SERVICE BULLETIN

TITLE: FLIGHT CONTROLS - RUDDERVATOR DIFFERENTIAL TAIL CONTROL ROD ASSEMBLY INSPECTION/MODIFICATION

Issued: September, 1996
Revised: December, 1998

SB 2668, Rev. 2

Ruddervator Differential Tail Control Rod Assembly
Figure 1

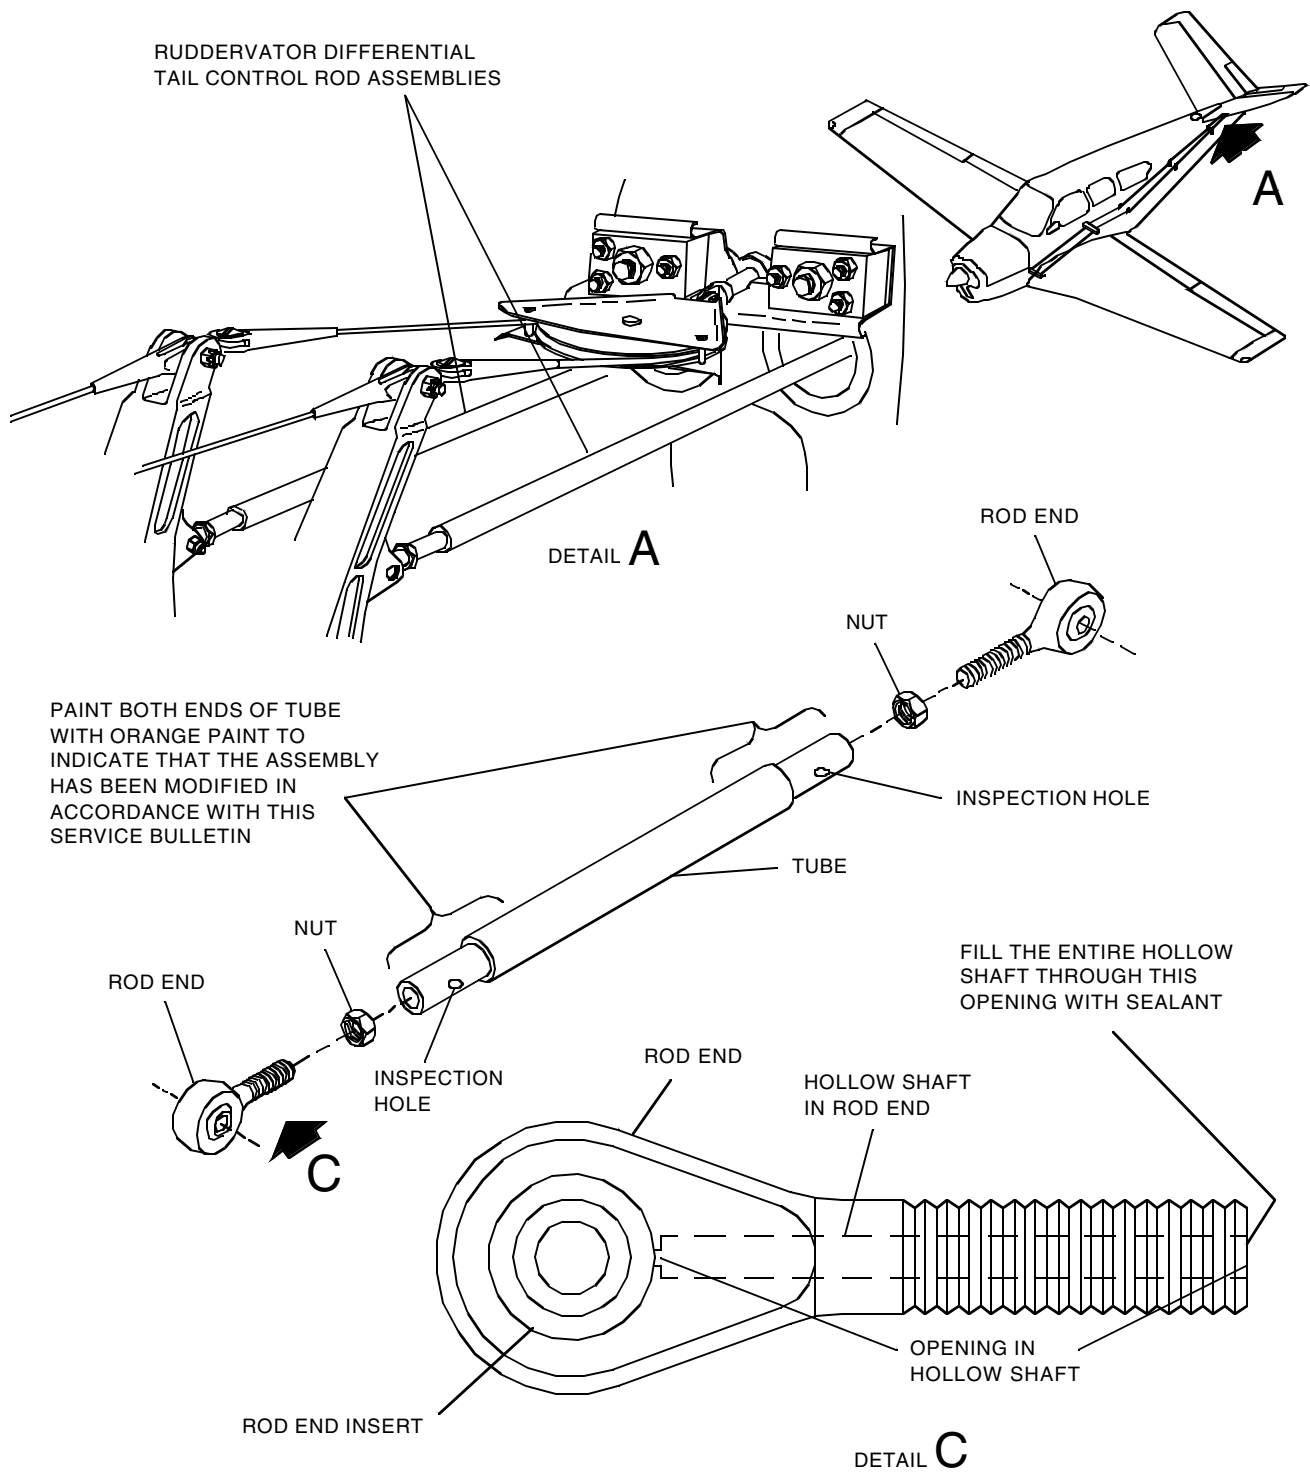
Each differential tail control rod assembly has two rod ends which are installed in the ends of the assembly. These rod ends (with the exception of P/N AHM4-1006) have a hollow shaft which is open at both ends and extends through the length of the rod end. It appears that through the process of the rod assembly "breathing", moisture laden air enters the rod assembly through the hollow shaft in the rod ends and condenses in the rod assembly tube. The accumulation of moisture in the assembly tube, in the presence of freezing temperatures, may cause the tube to split and possibly lead to the ruddervator not operating properly.

This Service Bulletin is being issued to inspect the two existing P/N 35-524106 or P/N 35-524106-8 ruddervator differential tail control rod assemblies for moisture and corrosion, repair or replace the assemblies (if necessary), seal the assemblies against moisture intrusion, and reidentify the modified assemblies.

It is not necessary to modify P/N 131765-8M, P/N 35-524106-9 rod ends (that have a sealed shaft) or P/N AHM4-1006 rod ends (which have a solid shaft) that have been installed on either differential control rod assembly. However, they will need to be inspected for cracks and corrosion in accordance with step 10. Proceed with the following steps for other parts affected.

- (14) If no cracks or corrosion are found in the rod ends perform the following steps using Detail C for reference:
 - (a) Clean the hollow shaft in each rod end with solvent and allow to dry.

- (b) Fill the hollow shaft with P/N MIL-S-8802, Class B sealant and allow to cure.
 - (c) After the sealant has cured, lubricate the ball and groove in the rod end insert with P/N MIL-G-23827 grease.

- (d) Reidentify the modified rod end as P/N 35-524106-9 using an indelible marker.
- (15) Apply P/N MIL-C-22750 orange epoxy, enamel, or polyurethane paint to the first two inches of each tube end and allow to dry. If corrosion preventative compound is present when the paint is to be applied, remove it with P/N MIL-C-38736 solvent before painting.

In order to insure adequate thread engagement, be sure that the rod end threads are visible in the rod assembly tube inspection holes (located at both ends of the tube) after the rod ends have been adjusted to obtain the recorded length. If the inspection holes are not present, be sure that the engaged rod end does not extend more than 1 5/8 inches past the end of the tube (distance is measured from the end of the tube to the center of the rod end insert).

- (a) The modified P/N 35-524106 rod assemblies become P/N 35-524106-11 rod assemblies.
 - (b) The modified P/N 35-524106-8 rod assemblies become P/N 35-524106-13 rod assemblies.
